**Vizcaya Ph. 6D
FINAL PLAT FP1803-003**

REQUEST: Final plat for 51 single-family residential lots

DATE OF REVIEW: April 18, 2018

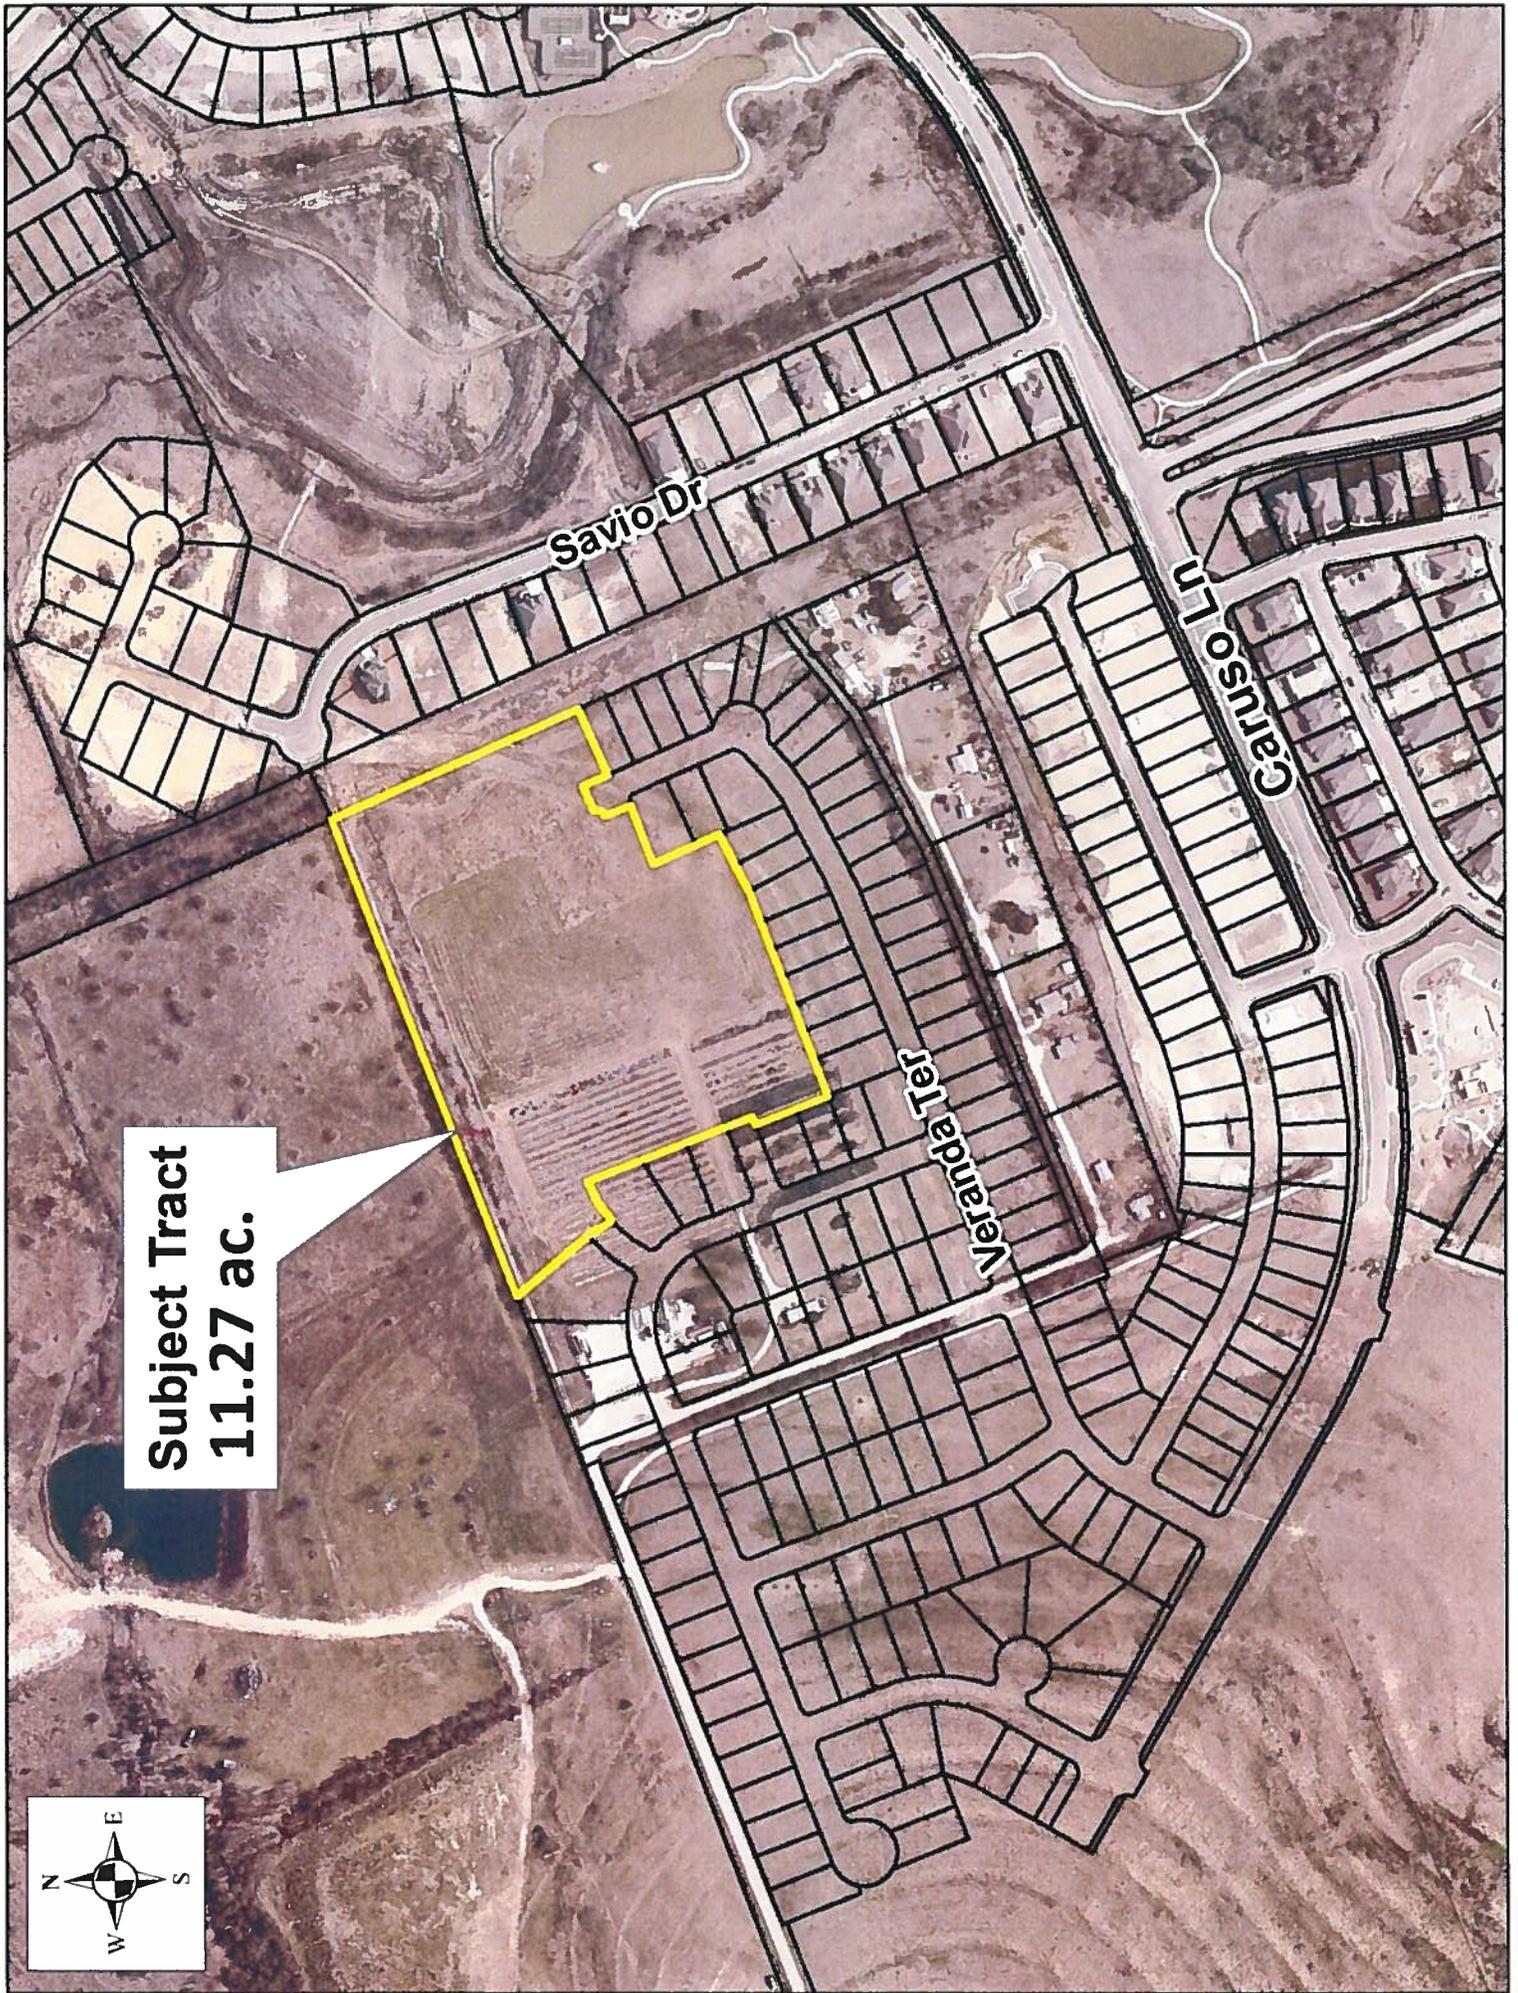
1. Prior to recordation, Bocelli Place cul-de-sac shall meet the standard design criteria noted in the street design criteria manual, specifically, Figure 1-23. This shall mean a 50' radius at the face of curb and C5 shall have a radius between 15'-25'.

2. Prior to the recordation of phase 6D, construction of phases 6A, 3E, and 3F must be accepted.
3. Correctly call out the document over the Georgetown right-of-way crossing as a deed. Georgetown is requiring a license agreement before this is utilized as an emergency access. Alternatively, this offsite area depiction with document callout is not needed for plat approval and can be removed.

4. Provide a note: Emergency access across Georgetown right-of-way requires additional authorization from Georgetown above and beyond the deed indicated. Alternatively, this offsite area depiction with document callout is not needed for plat approval and can be removed.

5. Prior to recordation, provide county recordation information for 0.290-acre tract access easement (easement list no. 4). Alternatively, this area depiction with document callout across Lot 43 Block HH is not needed for plat approval and can be removed.

6. Clearly identify north-south easement line work that appears in the center of Veranda Terrace right-of-way from line L4 to Lot 43 Block HH. Provide an identifying callout down near Lot 83.

7. Prior to recordation, provide county recordation information for Vizcaya Phase 3F in the allotted space along the southern boundary.
